## Modifications Notices

No. 2018127AE(ON)

**Modification Notice of changing the display contents and position of lot number aimed at strengthening traceability of DIP switch type A6SN / A6TN series.**

Model A6SN/A6TN series.

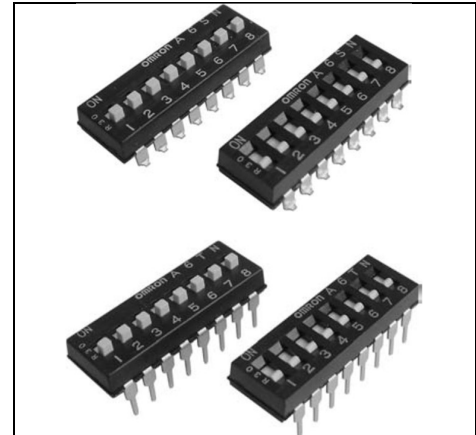
Before the change	After the change
<p><b>Position change of marking</b> Top marking</p> <p>Marking Position</p>	<p><b>Position change of marking</b> Side marking</p> <p>Marking Position</p>
<p><b>Method change of marking</b> Ink seal</p>	<p><b>Method change of marking</b> Laser marking seal</p>
<p><b>Indication change</b></p> <p>Year of Production Month of Production Days of Production</p>	<p><b>Indication change</b></p> <p>Internal management One Blank Year of Production Month of Production Days of Production</p>
